**Title:** 24-401: Burl Oaks Golf Course Redesign

**Prepared by:** Name: Maggie Menden  
mmenden@minnehahacreek.org

**Recommendation:**

Approval of the Minnehaha Creek Watershed District (MCWD) permit on the following conditions:

# PROPOSED FESCUE AREAS WHERE BUFFER REQUIRED

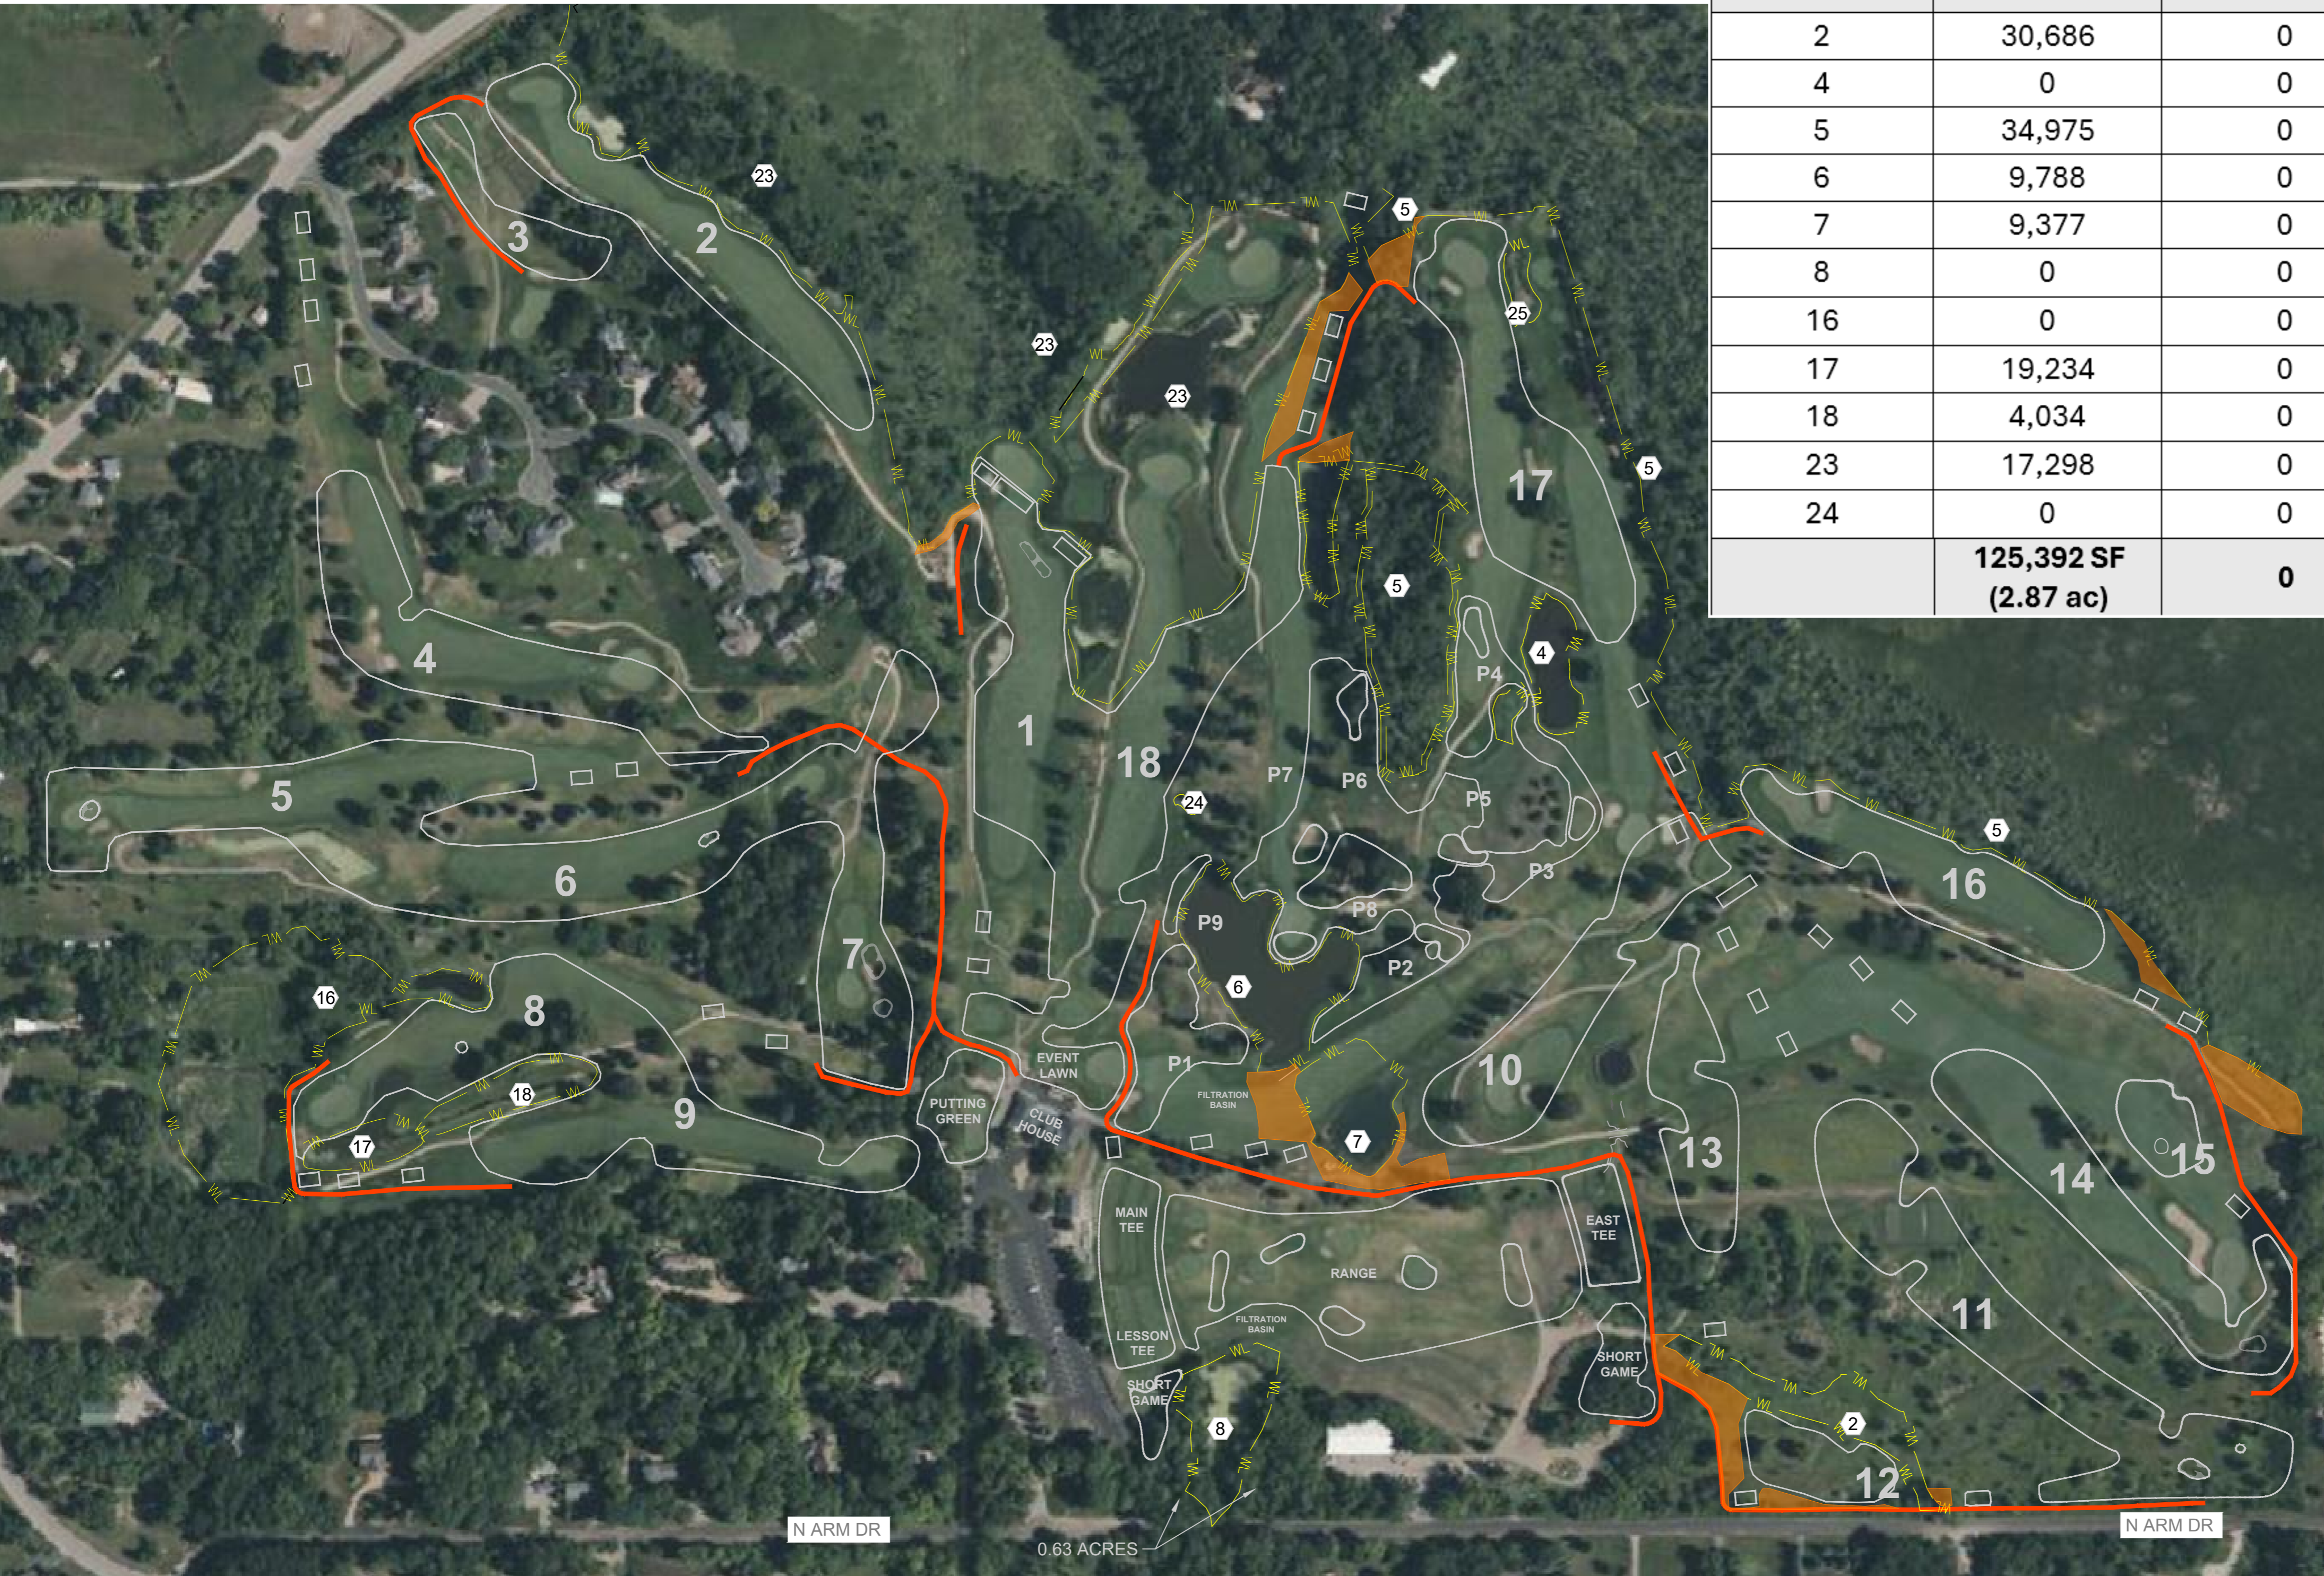
The applicant is proposing 2.26 acres of low maintenance fescue that will not receive irrigation or pesticide and fertilizer applications. This is not eligible as wetland buffer, generally due to it being a monoculture, receiving periodic mowing, and not being permanently protected through a declaration. However, this area will provide water quality function resembling wetland buffers and represents 79% of the total wetland buffer required.

Figure 1. Post Project Wetlands and Wetland Restoration Area

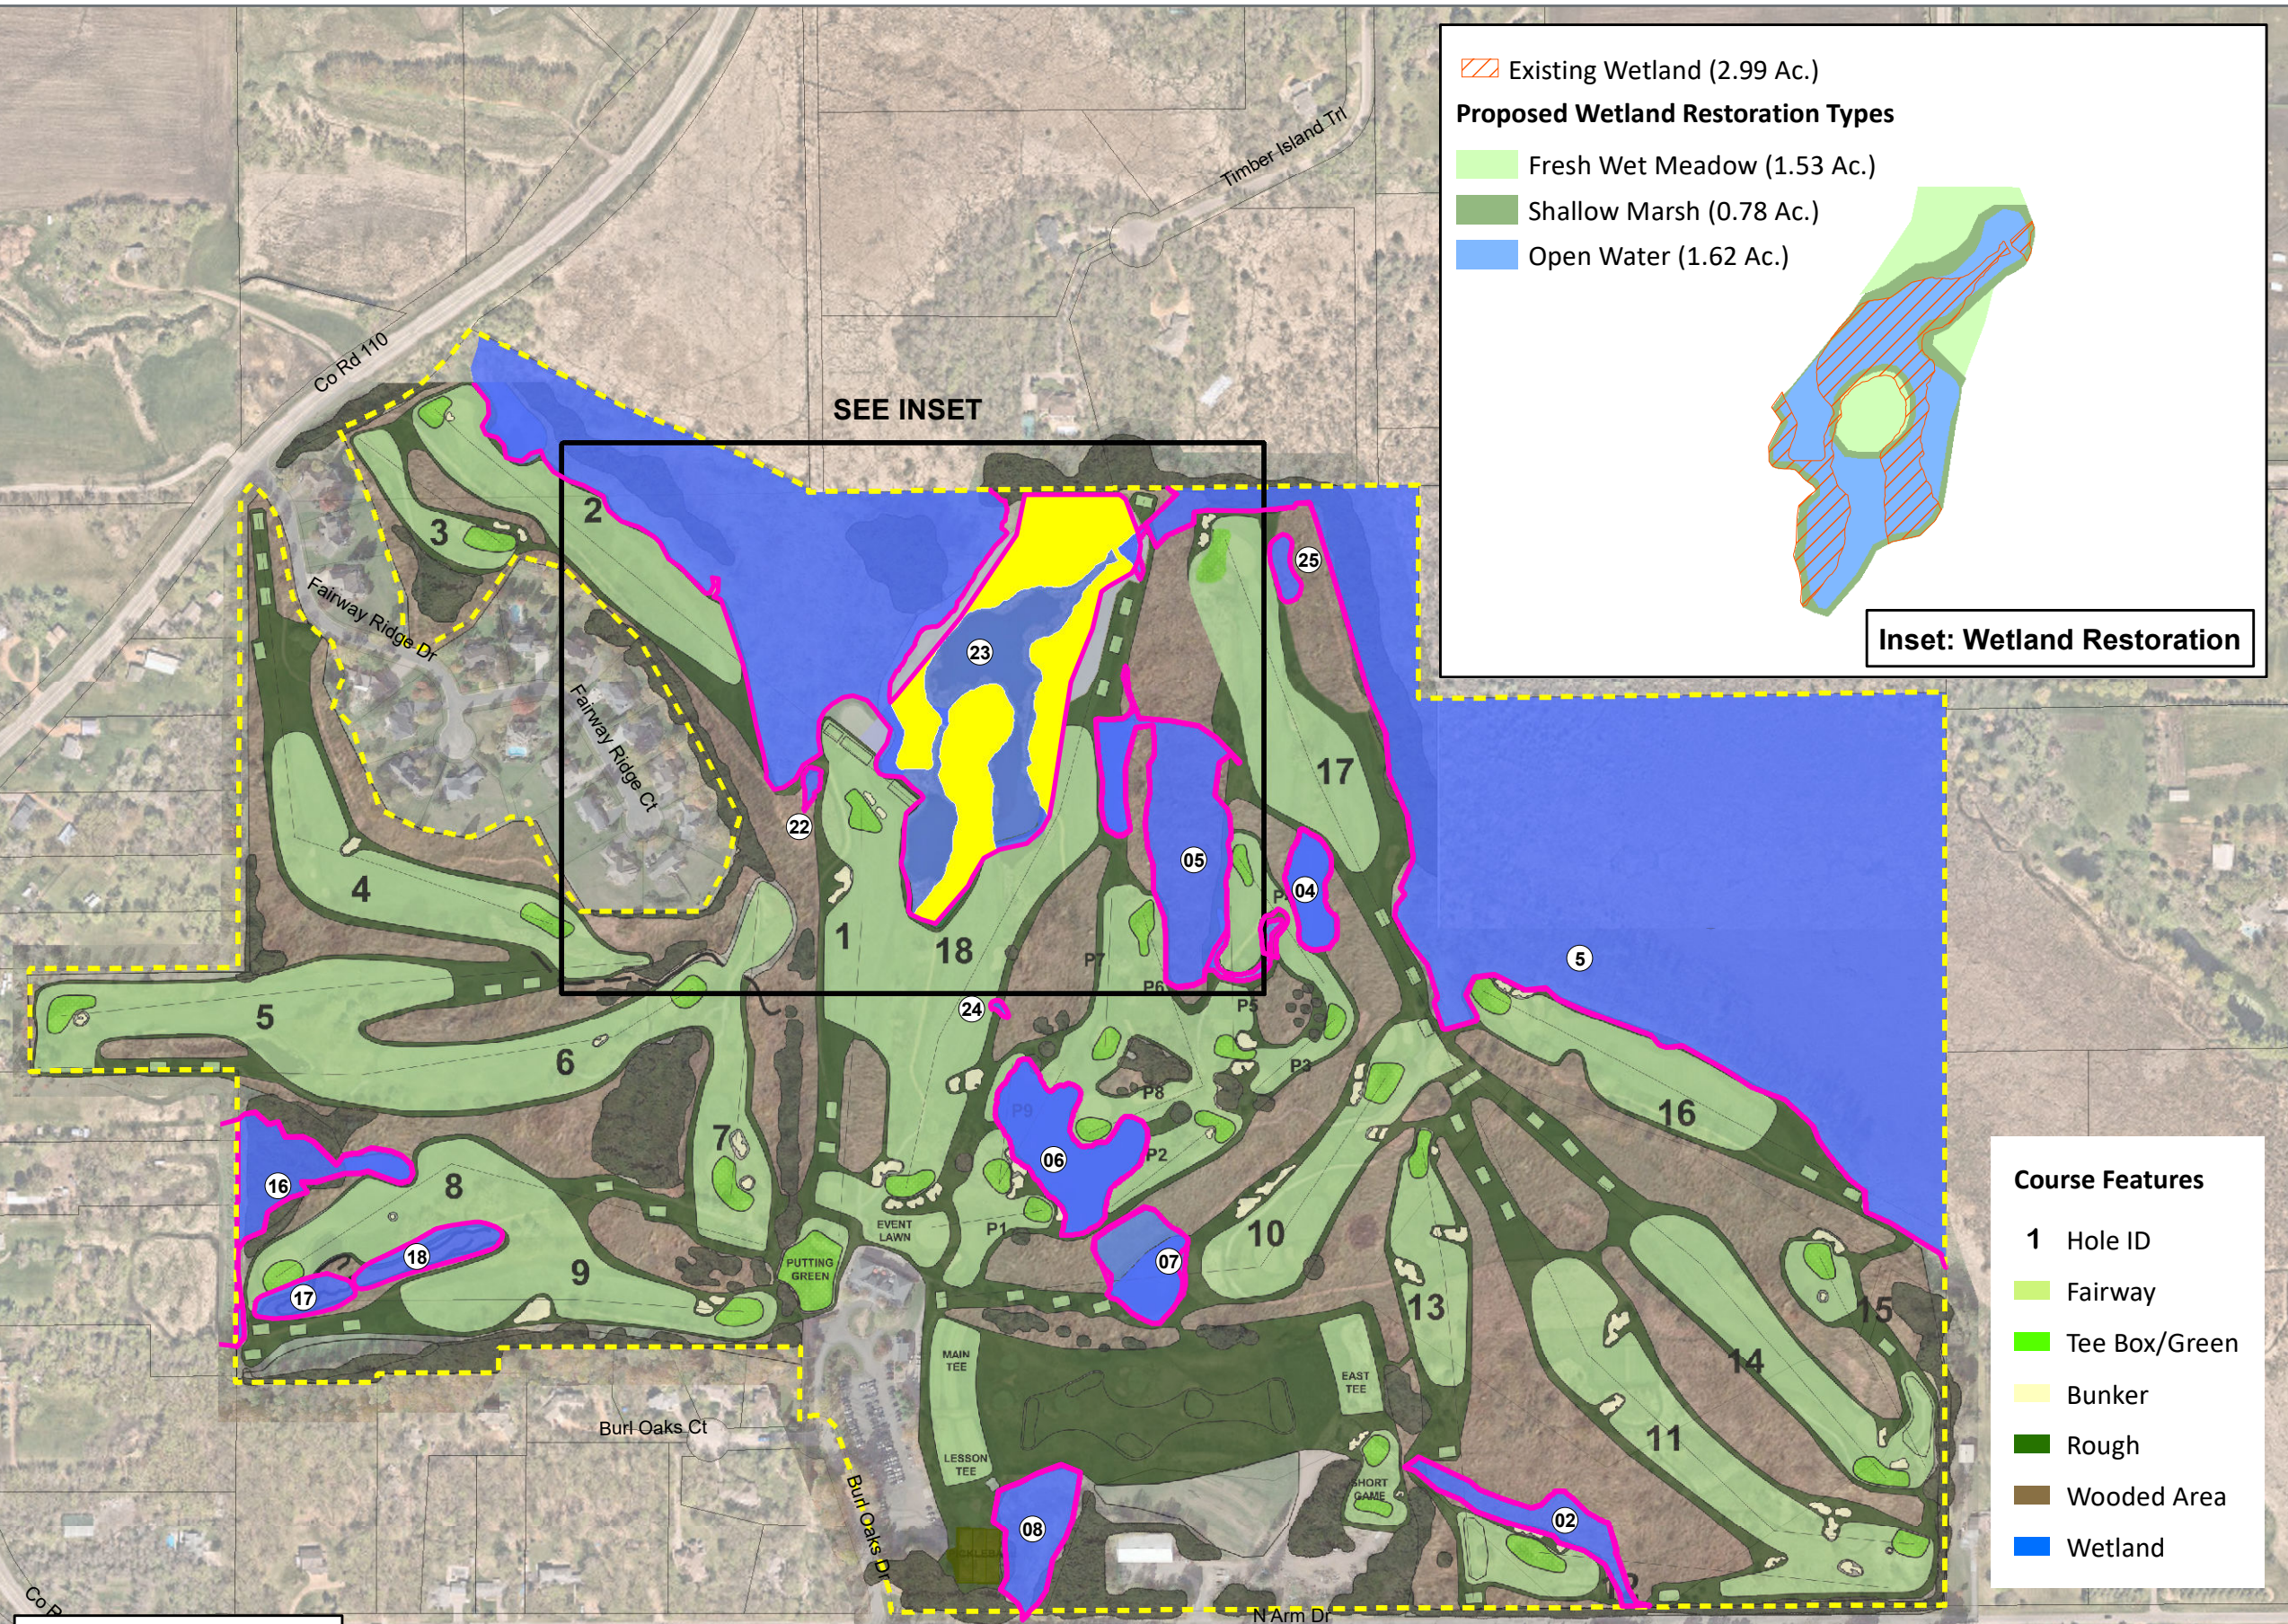
The applicant proposes to remove historic wetland fill, placed to facilitate development of the golf course in the 1960s, and restore 3.93 acres of wetlands directly through excavation to native grades at or below 956', to reach hydric soil map units and the area's wetland hydrology determined from the original wetland delineation. These areas will be natively seeded as detailed in Appendix A of the proposed restoration plan (Attachment E). MCWD sought the opinion of wetland restoration professionals with Moore Engineering who found the proposal to provide a feasible strategy to restore wetland communities, based on the presence of hydric soils, area hydrology, and the proposed grading and seeding plan (Attachment F).
